Re: Appeal No. 2026-12776-APPL of Case No. 2026-12126-HDRB, 515 Paseo de Peralta
Appellants' Response to the City Attorney's Memorandum dated September 25, 2026
Governing Body meeting of September 30, 2026

APPELLANTS' EXHIBITS 1–5

Appeal No. 2026-12776-APPL of Case No. 2026-12126-HDRB

515 Paseo de Peralta

Proposed East Elevation: addition rises 8'-0" above the historic parapet

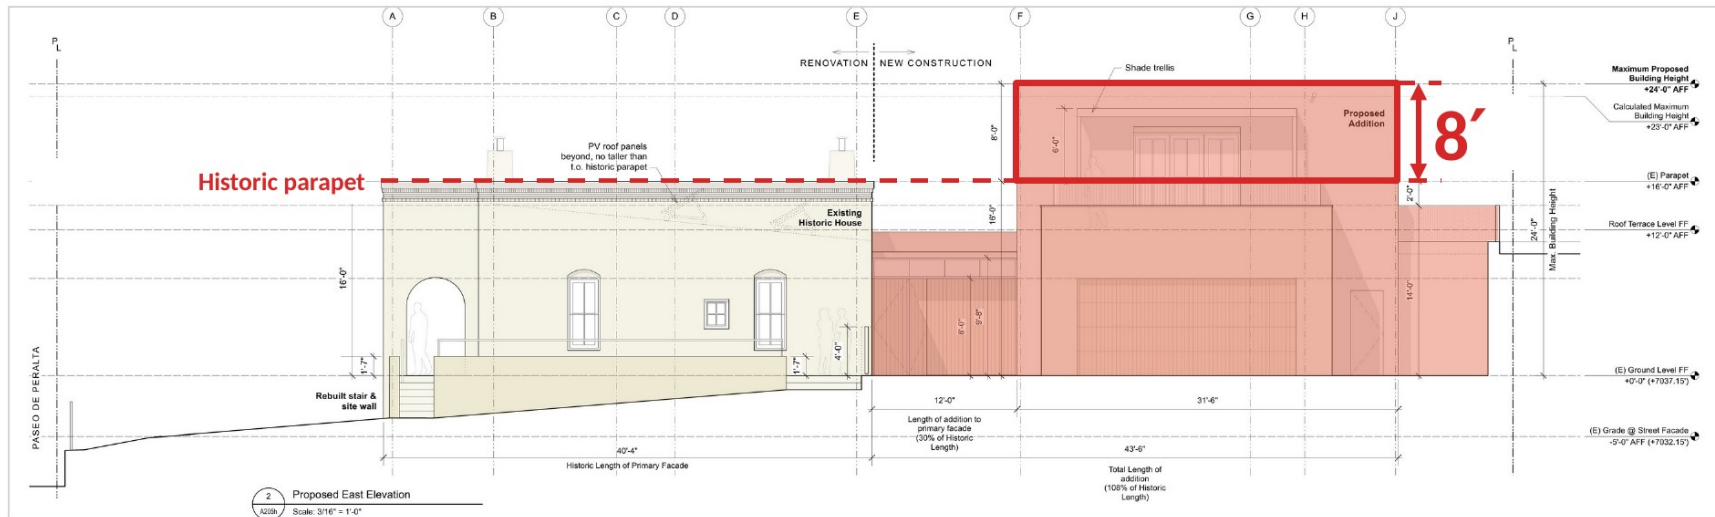
From the applicant's own dimensions: the top of the addition is **8'-0"** higher than the historic parapet. The Code requires the addition to be at least **six inches lower**.

SFCC § 14-4.6(E)(2)(III)(a): "The maximum height of building additions to significant and landmark structures shall be at least six inches lower than the parapet or equivalent roof feature of the existing adjacent connecting facade."

Proposed South Elevation (street-facing facade): 29'-0" above grade

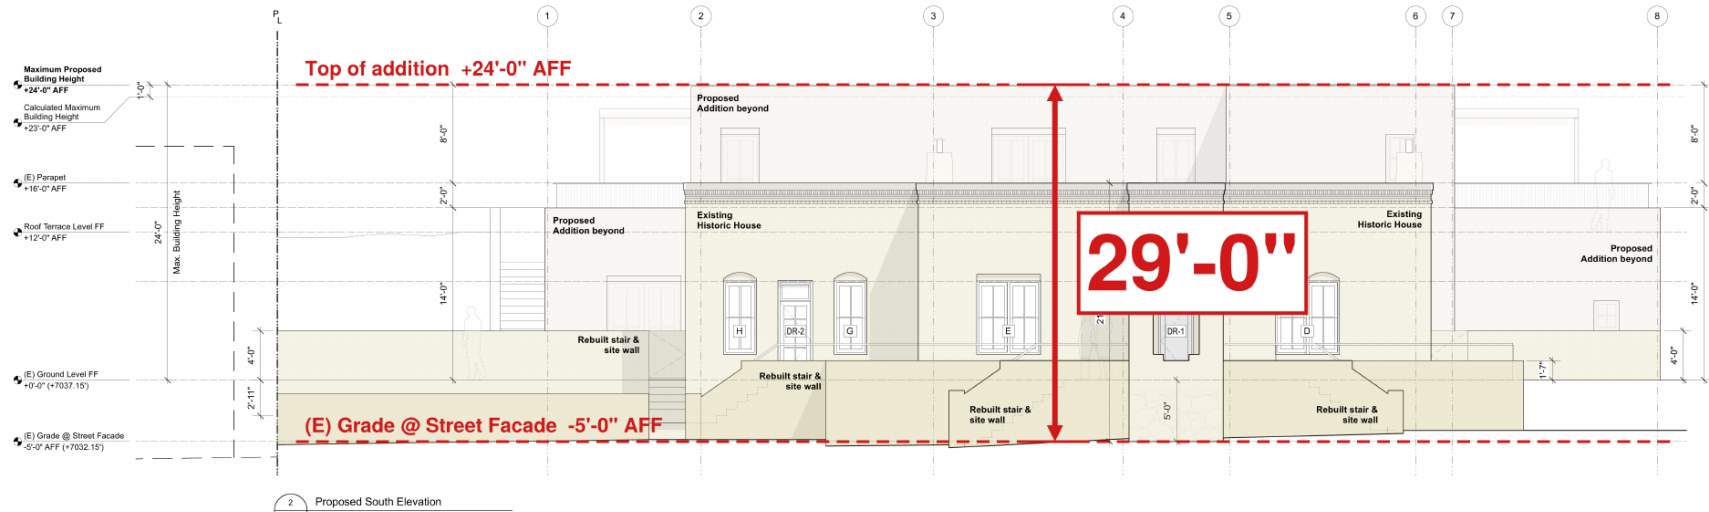
From the applicant's own dimensions: maximum proposed building height +24'-0" AFF (above the ground-level finished floor) + ground-level finished floor 5'-0" above the line the applicant labels "(E) Grade @ Street Facade, -5'-0" AFF" = 29'-0" above grade.

SFCC § 14-4.6(F)(2)(III)(a): "In historic districts, height shall be the vertical distance measured between the highest part of a structure and the existing grade or finished grade, whichever is more restrictive, at the midpoint of the street-facing facade..."

Proposed West Elevation: addition rises 29'-0" above grade at the street facade

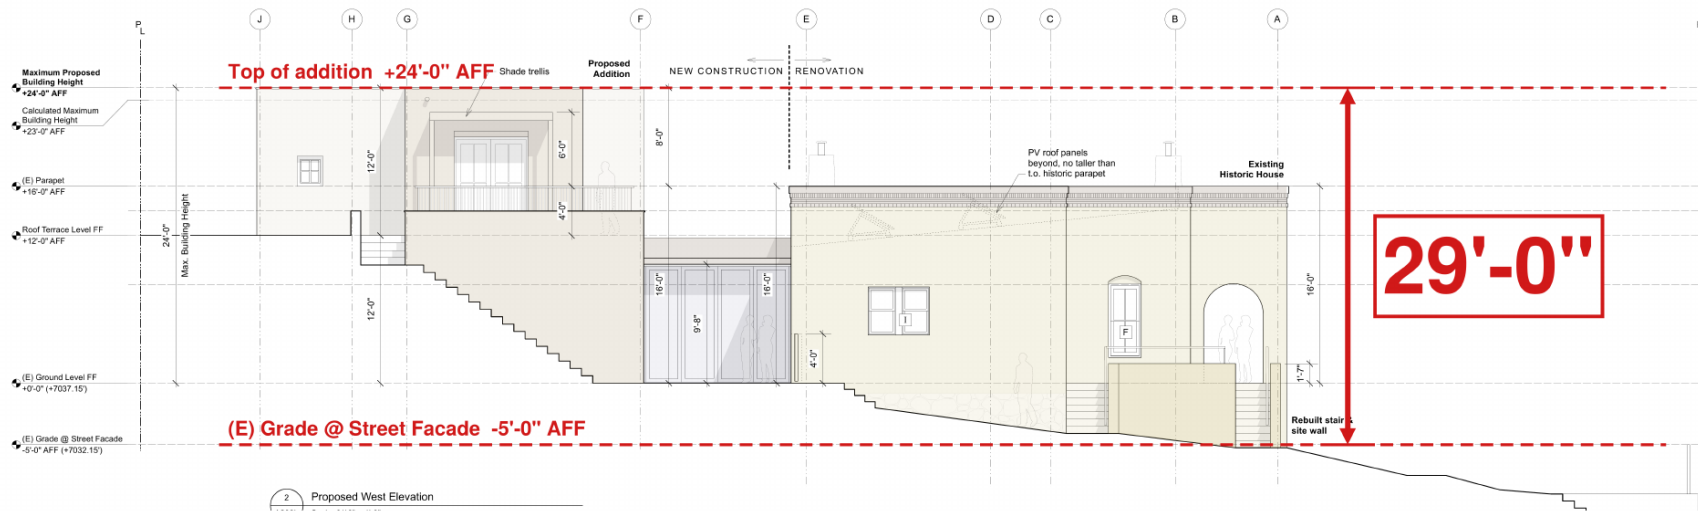
From the applicant's own dimensions: maximum proposed building height +24'-0" AFF (above the ground-level finished floor) + ground-level finished floor 5'-0" above the line the applicant labels "(E) Grade @ Street Facade, -5'-0" AFF" = 29'-0" above grade.

SFCC § 14-4.6(F)(2)(III)(a): "In historic districts, height shall be the vertical distance measured between the highest part of a structure and the existing grade or finished grade, whichever is more restrictive, at the midpoint of the street-facing facade..." The west elevation is shown because it presents the full two-story addition against that same grade datum.

Height Exceeds Streetscape Limit

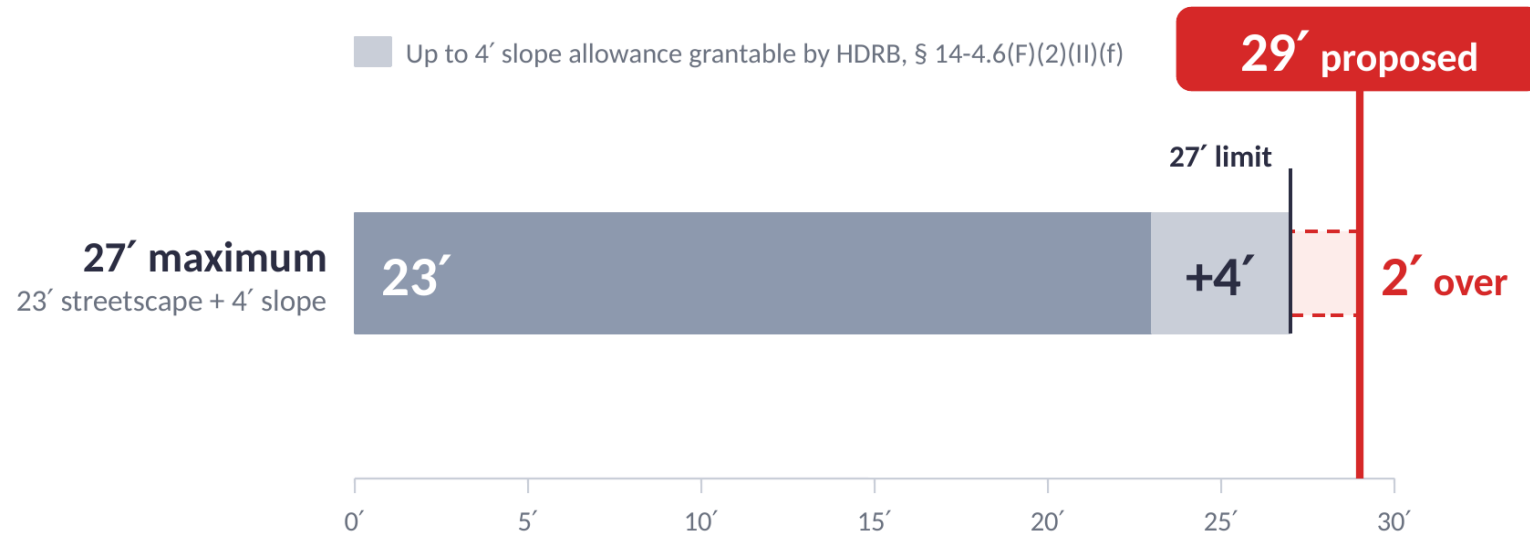
Streetscape limit **23'** (staff calculation, Ex. E at 45) + up to **4'** that the HDRB may grant for a sloping site = **27' maximum**. The addition is **29'** above grade (Exhibits 2A, 2B), **2' over the maximum**.

SFCC § 14-4.6(F)(2)(II)(f): "The HDRB may increase the allowable height for proposed buildings and additions located on a sloping site where the difference in the natural grade along the structure's foundation exceeds two feet. In no case shall the height of a façade exceed four feet above the allowable height of the applicable streetscape measured from natural or finished grade, whichever is more restrictive."

Addition Exceeds 50% Footprint Limit

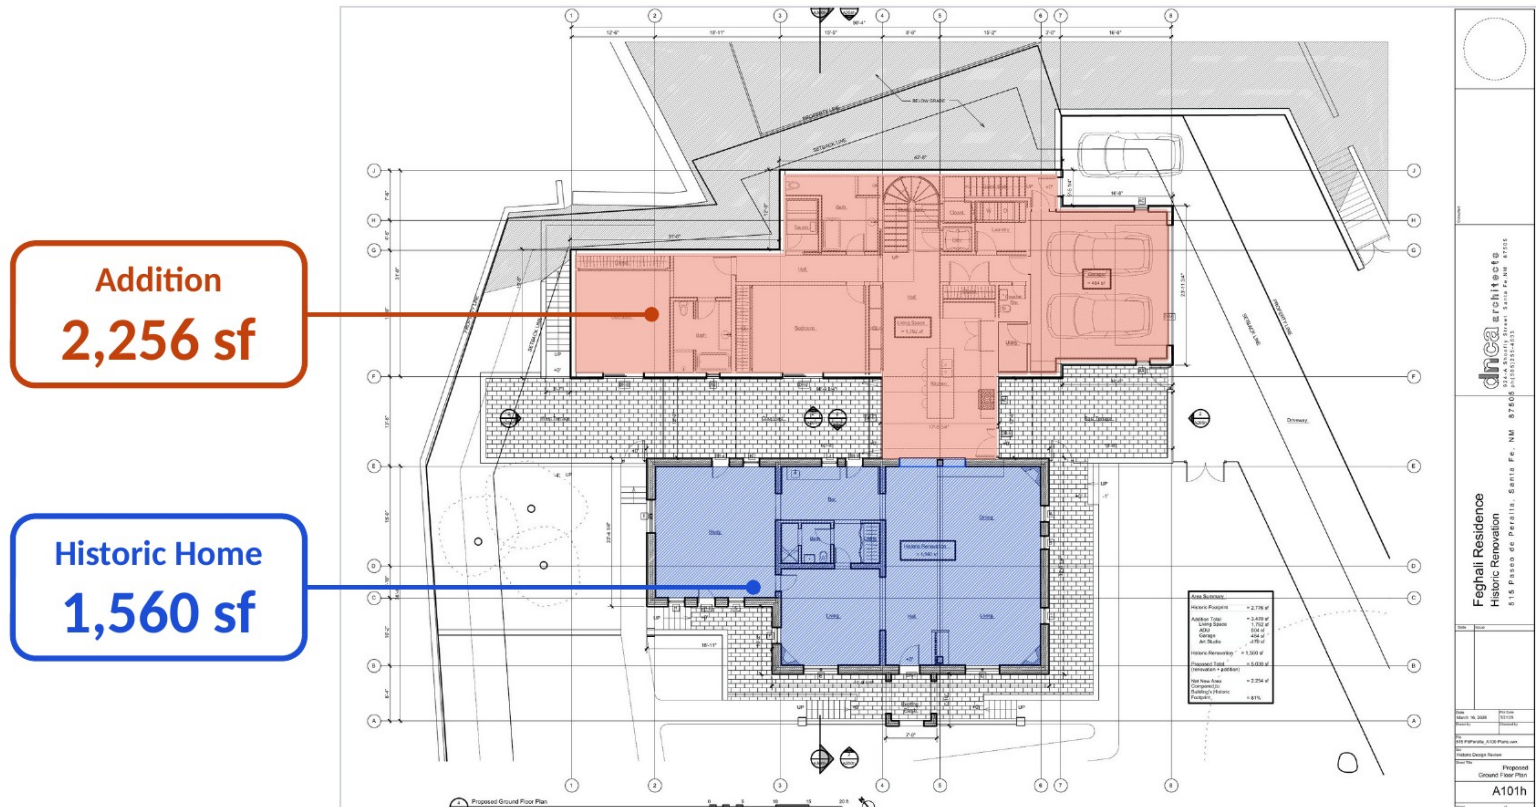
a. The “historic footprint” includes non-contributing and/or detached structures. The Memo and the Board's Finding 13 use a historic footprint of 2,776 square feet (Memo at 1, 3; Ex. B at 12). The applicant's own narrative states: “The existing house's historic footprint measures 2,776 sf, including existing noncontributing additions to be demolished.” It gives the existing historic building as 1,560 square feet (Ex. D at 35; Ex. G at 55; Ex. H at 78). In Case No. 2025-10763-HDRB, on August 12, 2025, the Board retained Significant status for the residence “excluding the northwest addition, and excluding the original garage addition” (Ex. B at 9). Chair Rios asked for clarification of the historic footprint at the hearing (Ex. C at 18). Measured against the 1,560-square-foot Significant structure, the 2,256-square-foot addition footprint is about 145 percent of the historic footprint, not 81 percent. It is nearly 2.9 times the 780 square feet that § 14-4.6(E)(2)(II)(c) permits (Appellants' Exhibit 4).

Extra story means Contributing, not Significant

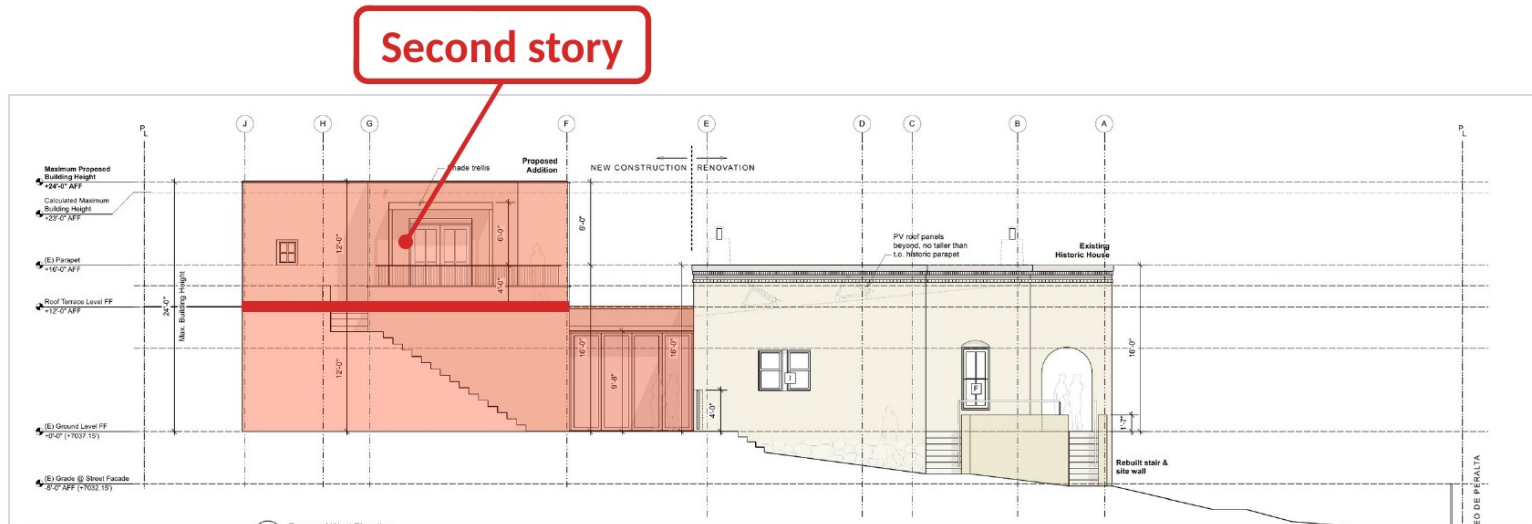
Significant: “The maximum height of building additions to significant ... structures shall be at least **six inches lower** than the parapet...” §14-4.6(E)(2)(iii)(a)

Contributing: “Building additions to contributing structures shall be no more than **one additional story** higher than the existing structure.” §14-4.6(E)(2)(iii)(b)
